#### License to Operate On-Site Sewage Treatment and Disposal Facility

## Permit of Authorization to Construct an On-Site Sewage Facility Permit Valid For One Year From Date Issued

permit 108932, Brandon Acres, Unit 1, Lot 1-A, 185 Mitchell Drive

We received planning materials for the referenced permit application on March 28, 2019 and found those planning materials to be deficient. In order to continue processing this permit, we need the following:

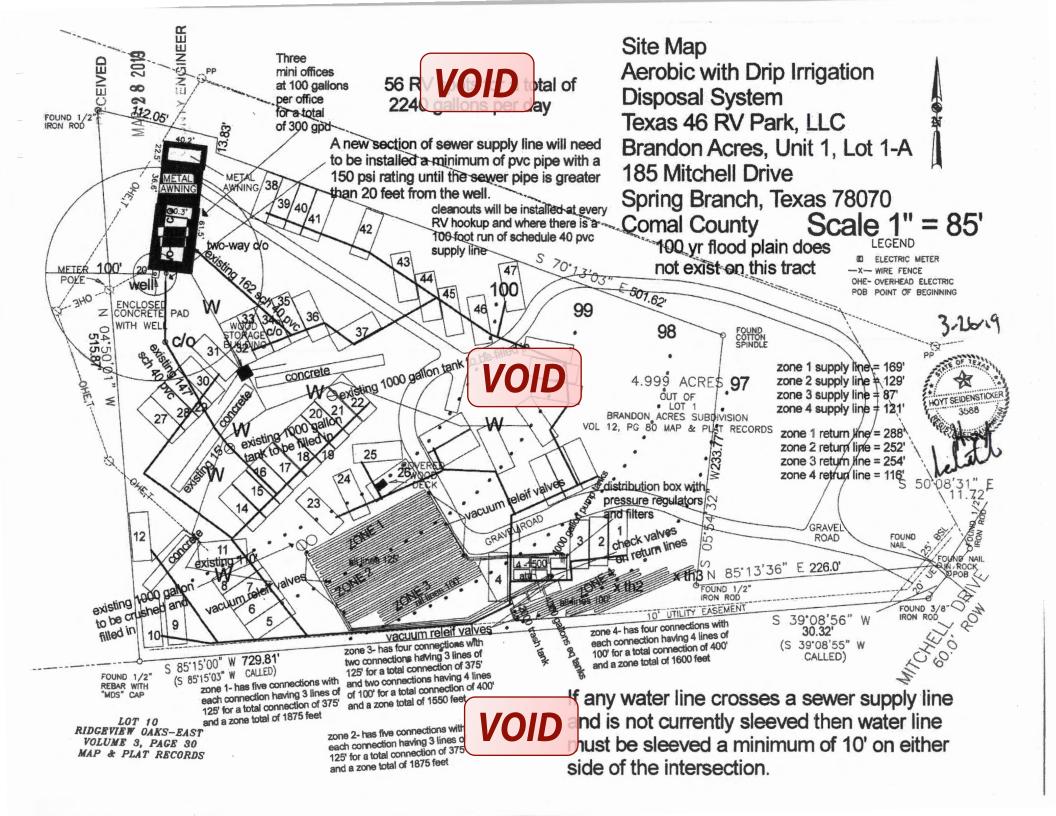
Identify all the RV locations, and show the waterline location to each RV pad.

Show the 150 foot water well radius.

9 Comal County rules and regulations require that new non-single family residential structures show adequate land area for doubling the required land needed for the treatment units and disposal area.

16\Show the cleanout location at every 100 feet of tightline.

1 Indicate if equivalent protection is needed for the sewer supply lines that appear to be located under the driveway.

12. Revise accordingly and resubmit.
